SUBJECT: AMENDMENT NO. 57 TO FACILITY OPERATING LICENSE NO. DPR-22:
INCREASED SODIUM PENTABORATE BORON-10 ENRICHMENT (TAC NO. 67430)

MONTICELLO NUCLEAR GENERATING PLANT

Amendment No. 57
License No. DPR-22

SAFETY EVALUATION BY THE OFFICE OF NUCLEAR REACTOR REGULATION
RELATED TO AMENDMENT NO. 57 TO FACILITY OPERATING LICENSE NO. DPR-22

Figure 3.4-1 Sodium Pentaborate Solution Volume Concentration Requirements

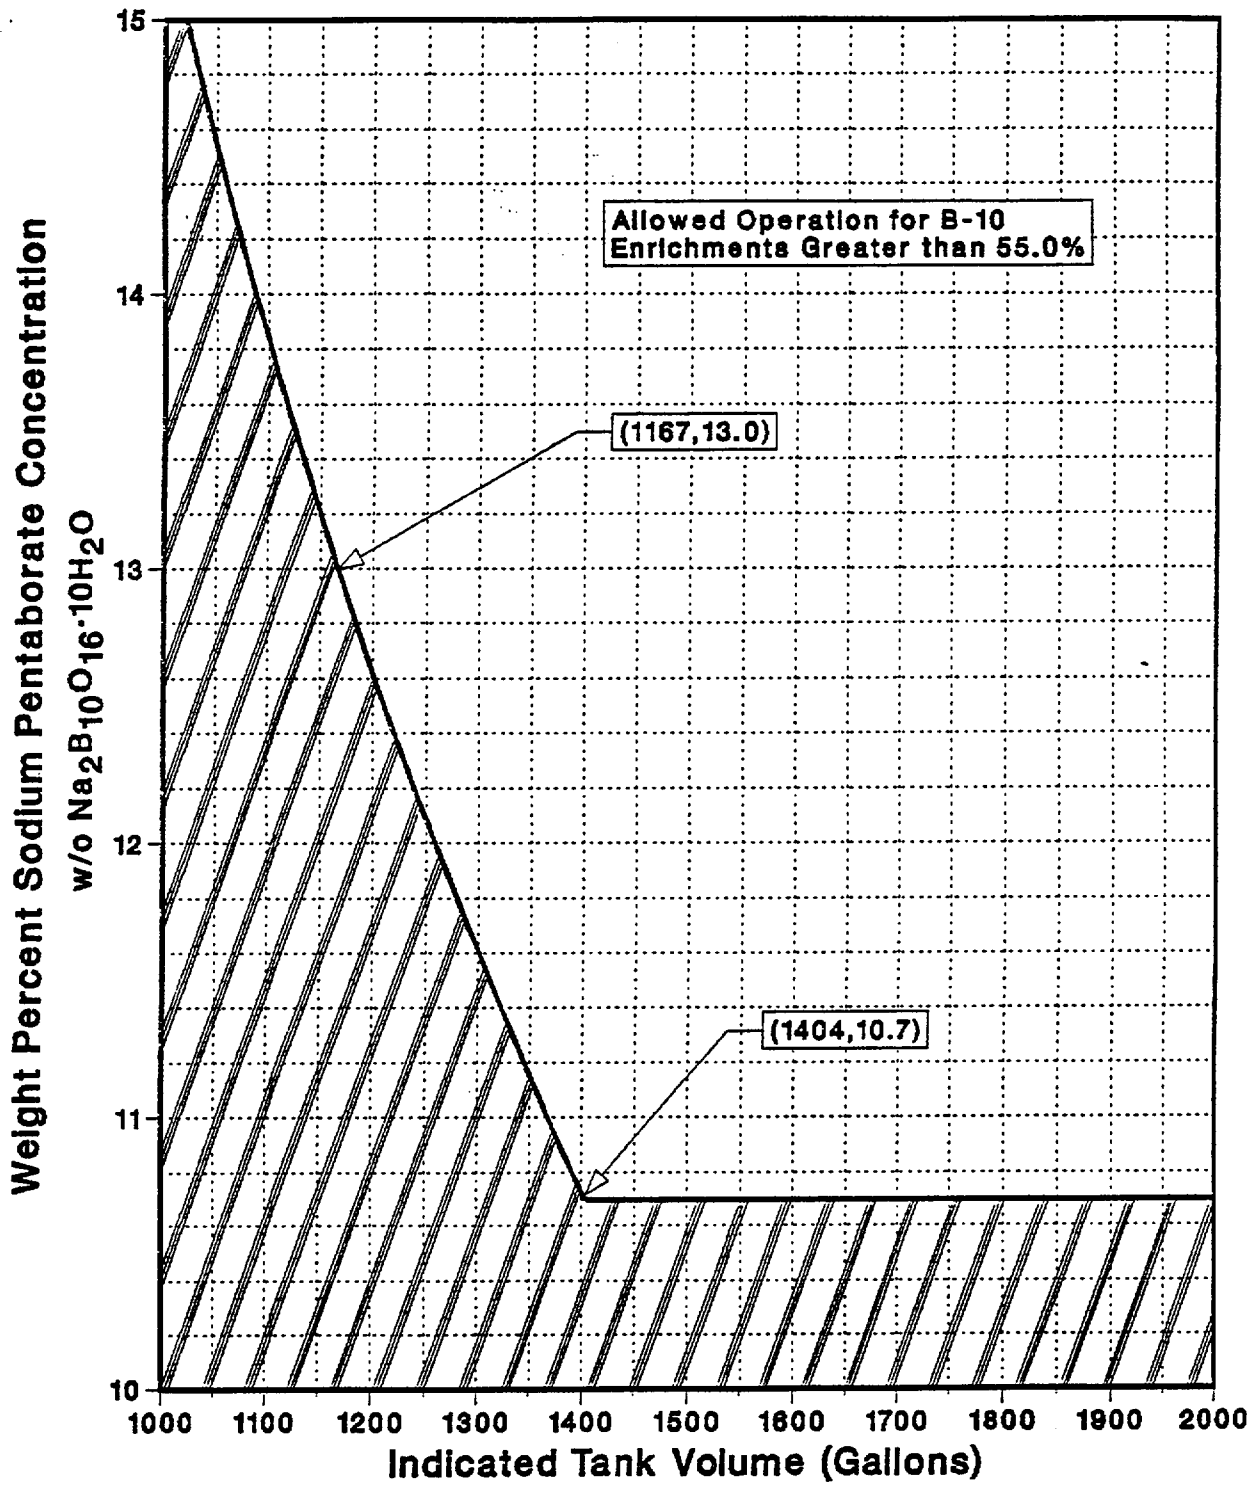
- Reduce the pump minimum flow rate in Paragraph 4.4.A.1 from 26 gpm to 24 gpm.
- Add a sentence in Paragraph 4.4.A.1 which reads, "Comparison of the measured pump flow rate against equation 2 of paragraph 3.4.C.1 shall be made to demonstrate operability of the system in accordance with the ATWS Design Basis".
- Add the words "indicated" and "measured" in the variable definitions contained in Paragraph 3.4.C.1.
- Delete the sentence in Paragraph 4.4.C.1 which reads, "In addition, the boron enrichment shall be determined any time new chemicals are added to the liquid poison tank".
- Replace Figure 3.4-1 which allows operation for B-10 enrichments greater than 39.6% with a new Figure 3.4-1 which allows operation for B-10 enrichments greater than 55.0%.

Substantive changes that have been proposed to the TSs include a) decreasing the required pump flow rate from 26 to 24 gpm, b) incorporating a new Figure 3.4-1 which is based on 55 atom percent enriched boron, and c) deleting the requirement for mid-cycle boron enrichment surveillance when new chemicals are added.

The curves in Figure 3.4-1 provide the boundaries which define an area of operation that ensures the original design basis and the ATWS Rule are satisfied. The equation for the lefthand curve or boundary is as provided in the discussion below entitled, "Comparison with the original design basis for the SLCS." The lower boundary is provided by a straight line at 10.7 wt percent below which the requirements of the ATWS Rule are not met if a pump flow rate

of 24 gpm and boron enrichment of 55.0 atom percent or 2.78 times that naturally occurring are assumed.

1. The liquid poison tank shall contain a boron bearing solution that satisfies the volume, concentration and enrichment requirements of Figure 3.4.1, or compliance can be demonstrated by satisfying the following equations:
